STAFF REPORT
COMMUNITY DEVELOPMENT DEPARTMENT

HEARING DATE: 8/11/2020
TO: Mayor & City Council
FROM: Sonya Allen, Associate Planner
208-884-5533
SUBJECT: H-2020-0066 Apex – MDA, AZ, RZ
H-2020-0056 Apex Northwest – PP
H-2020-0057 Apex Southeast – PP
(to be marketed as “Pinnacle”)

A. Master Plan (Revised)

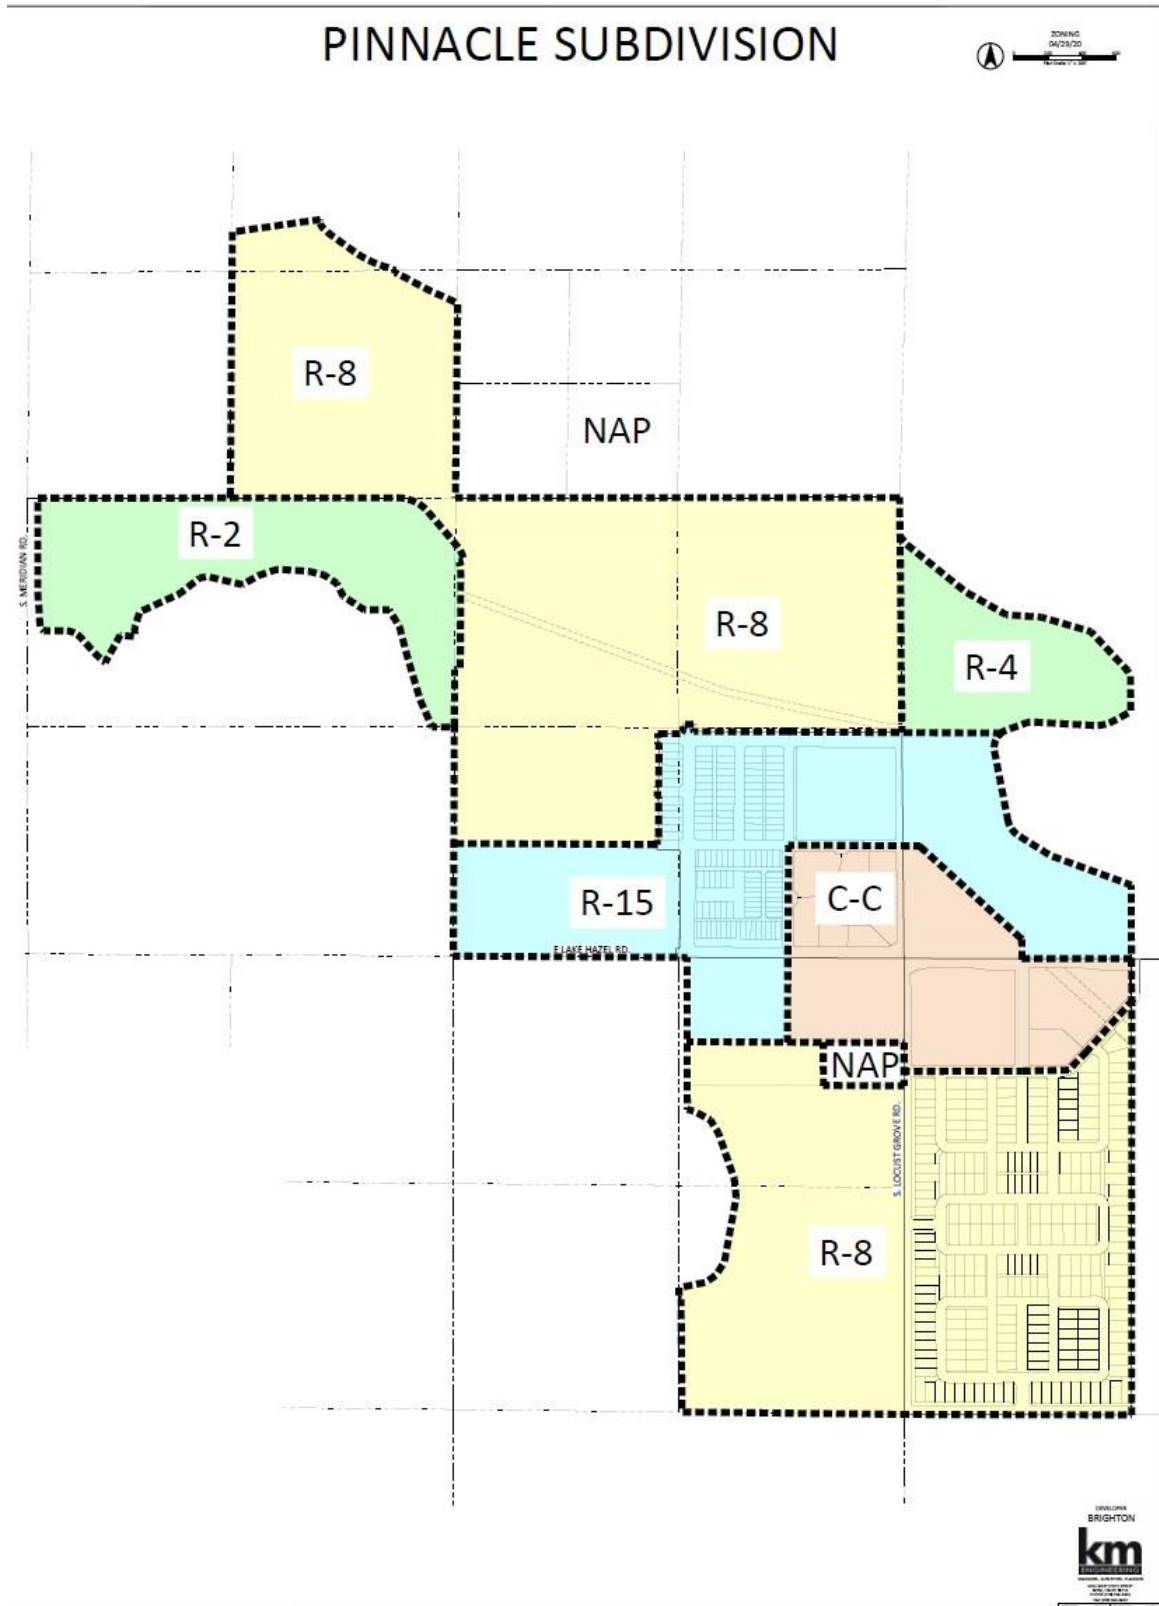
Staff recommends the proposed Master Plan is included in the new DA along with the provisions for future development listed in Section IX.A.1 to ensure compliance with the MU-C FLUM designation.

- a. Future development of this site shall be generally consistent with the conceptual master plan, conceptual building elevations, preliminary plat, phasing plan, landscape plan, and qualified open space exhibits included in Section VIII and the provisions contained herein.

- d. Prior to development of the Mixed Use – Community (MU-C) designated areas shown on the Master Plan as “future development,” the Development Agreement shall be amended to include a conceptual development plan that demonstrates consistency with the general guidelines for Mixed Use developments and specifically the MU-C designation (see pgs. 3-13 and 3-15 thru 3-16).

D. Preliminary Plat (date: 5/1/2020) & Phasing Plan

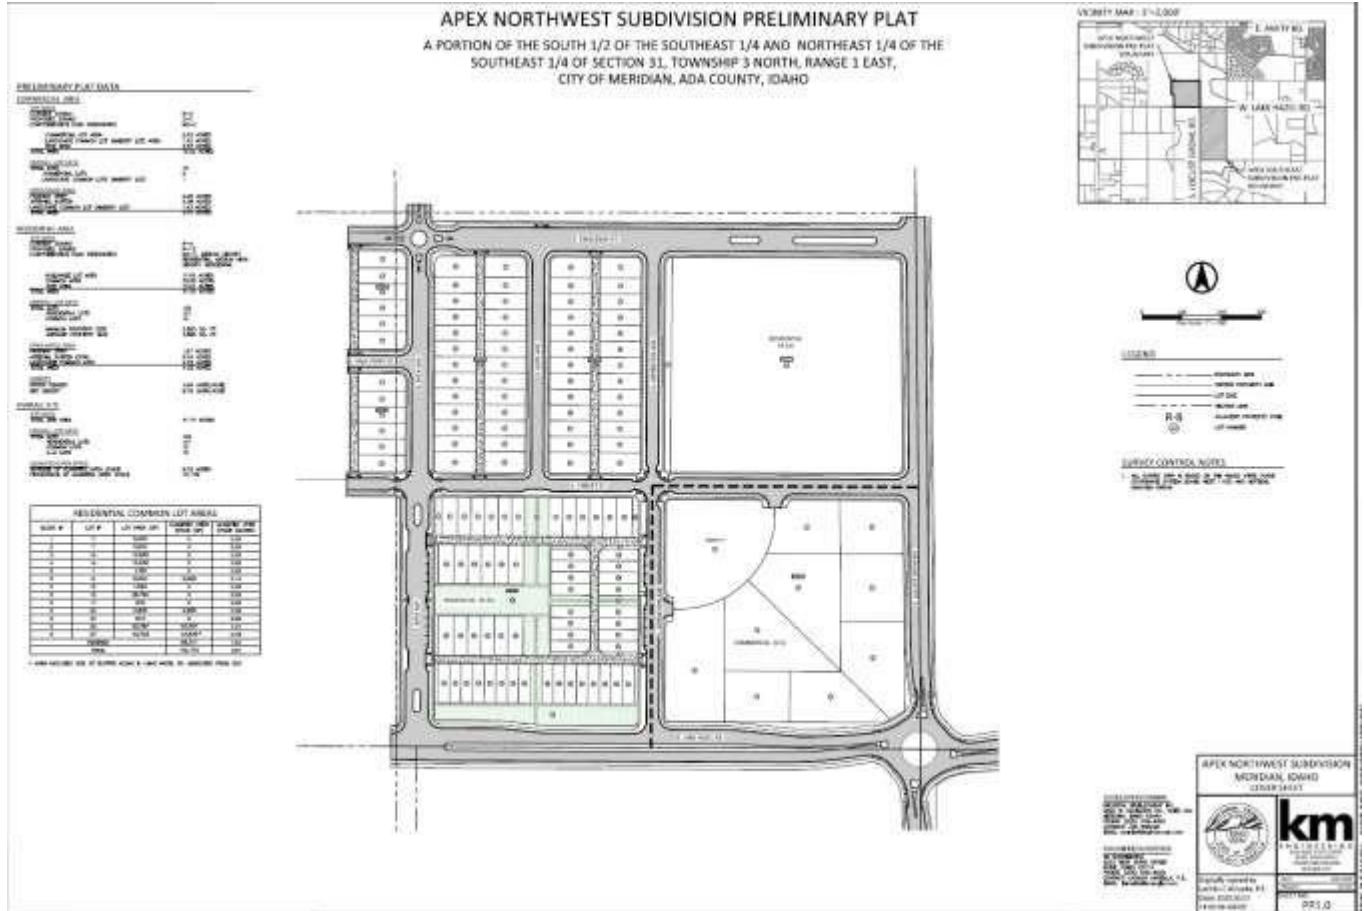
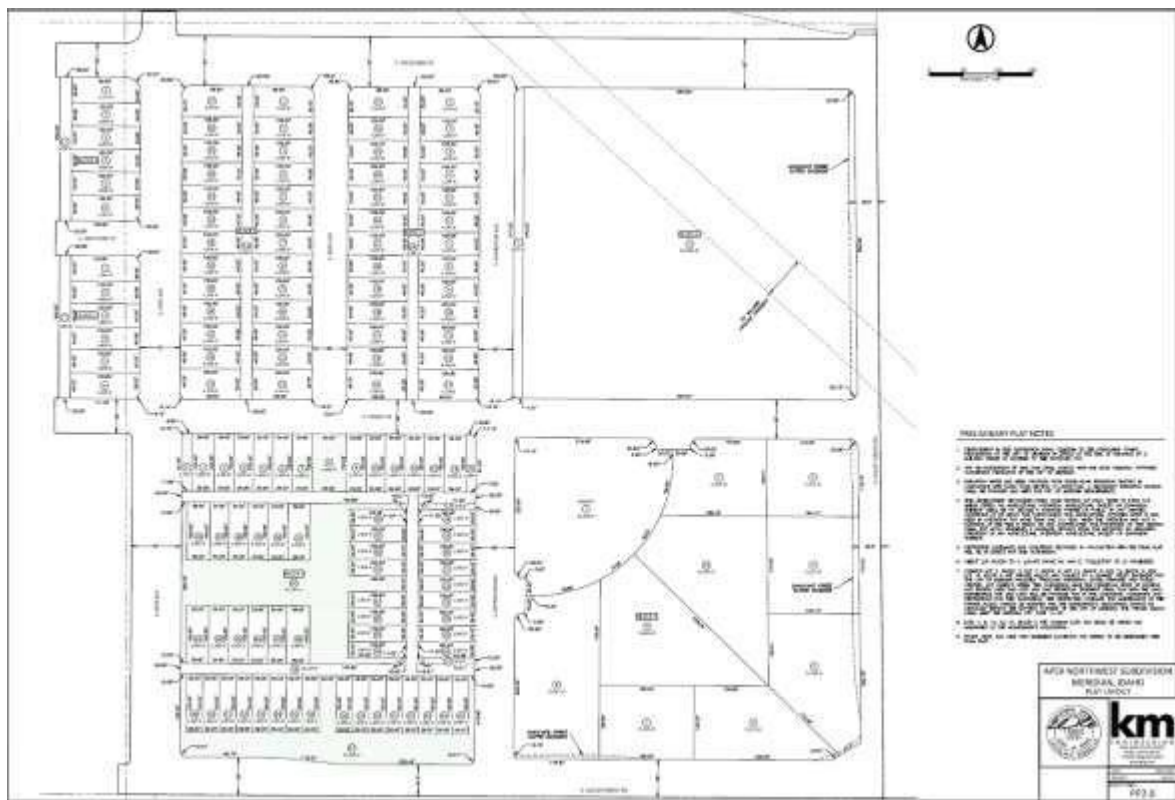
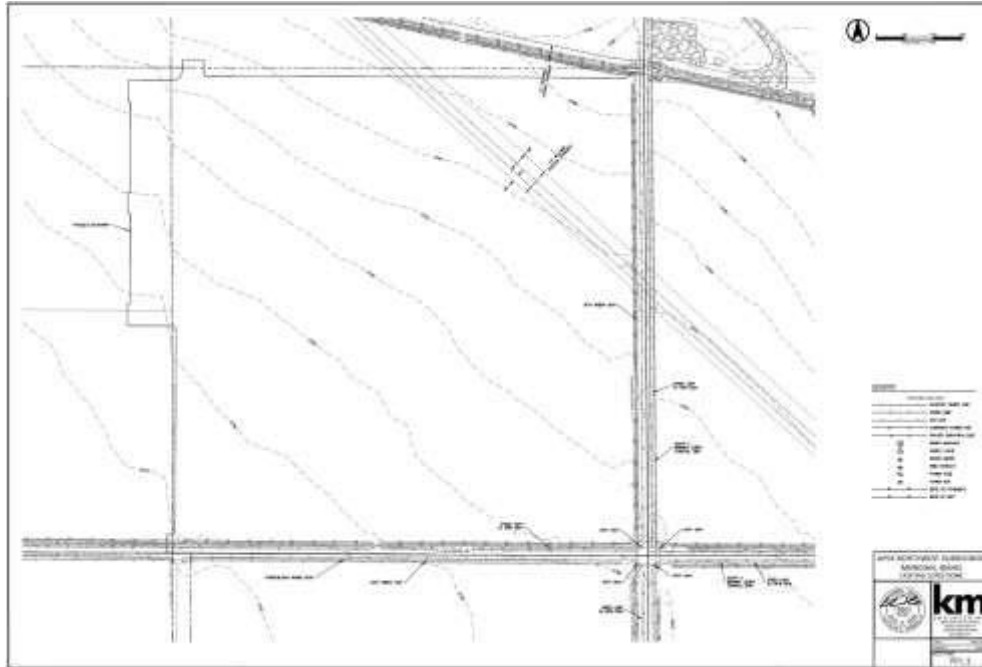
The proposed lots in Apex Northwest are consistent with the dimensional standards of the R-15 and C-C zoning districts. **However, one of the alleys is not designed so that the entire length is visible from a public street as required by UDC 11-6C-3B.5e; the plat should be revised to comply.** Common driveways that comply with the standards in UDC 11-6C-3D may be considered as an alternative.
